Project	IEEE 802.16 Broadband Wireless Access Working Group < http://ieee802.org/16 >	
Title	Time Frequency mapping of Downlink MIMO in OFDMA PHY	
Date Submitted	2005-1-13	
Source(s)	Danny Stopler, Ran Yaniv, Tal Kaitz, Naftali Chayat, Vladimir Yanover Alvarion Ltd.	danny.stopler@alvarion.com ran.yaniv@alvarion.com tal.kaitz@alvarion.com
Re:	Call for comments, maintenance task group	
Abstract		
Purpose		
Notice	This document has been prepared to assist IEEE 802.16. It is offered as a basis for discussion and is not binding on the contributing individual(s) or organization(s). The material in this document is subject to change in form and content after further study. The contributor(s) reserve(s) the right to add, amend or withdraw material contained herein.	
Release	The contributor grants a free, irrevocable license to the IEEE to incorporate material contained in this contribution, and any modifications thereof, in the creation of an IEEE Standards publication; to copyright in the IEEE's name any IEEE Standards publication even though it may include portions of this contribution; and at the IEEE's sole discretion to permit others to reproduce in whole or in part the resulting IEEE

Figure XXX – N-antenna STC transmission

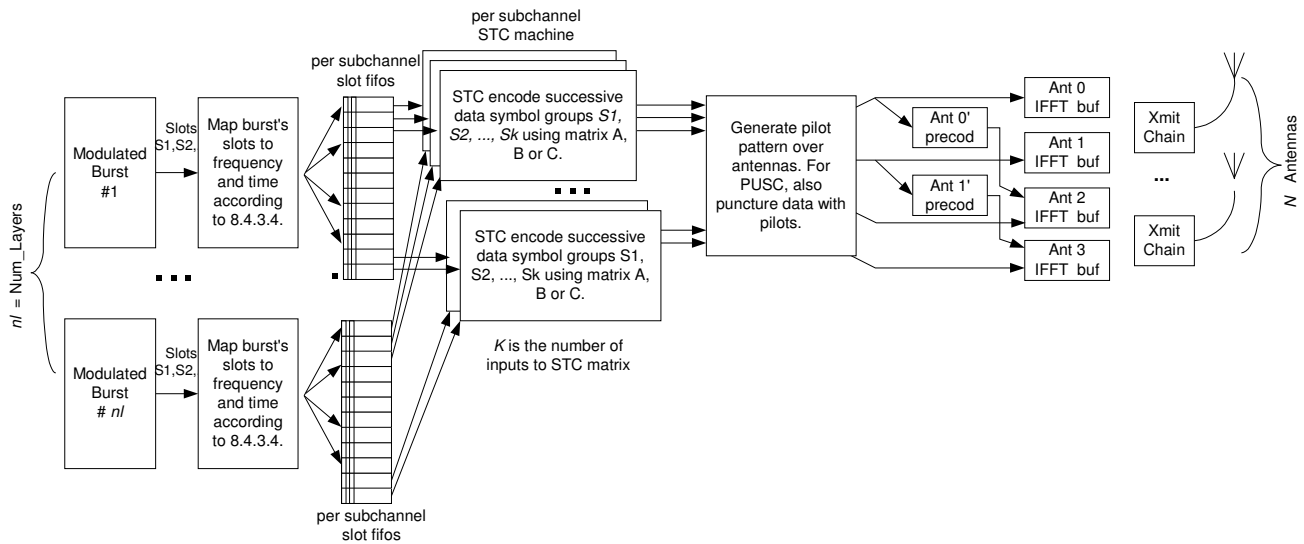
[Add text at the end of Section 8.4.8.2.3]

The multi antenna transmission is described in terms of slots, where the burst modulators fill (frequency first) a vector of per sub-channel fifos. The input of each fifo is slot based and the output of each fifo is OFDMA-symbol based. Each such fifo is connected to an independent STC machine, which reads the slots, processes them, and finally outputs STC encoded data symbols per antenna for the corresponding subchannel.

The multi antenna transmission is defined differently for horizontal (Num-Layers>1) and vertical coding (Num-Layers=1). Vertical coding indicates transmitting the coded stream of a single burst over multiple antennas, while horizontal coding indicates transmitting a separate burst per antenna. More specifically the schemes depicted in figure XXX are elaborated below. Each group S_x depicts the data symbols in a subchannel over one OFDMA symbol time:
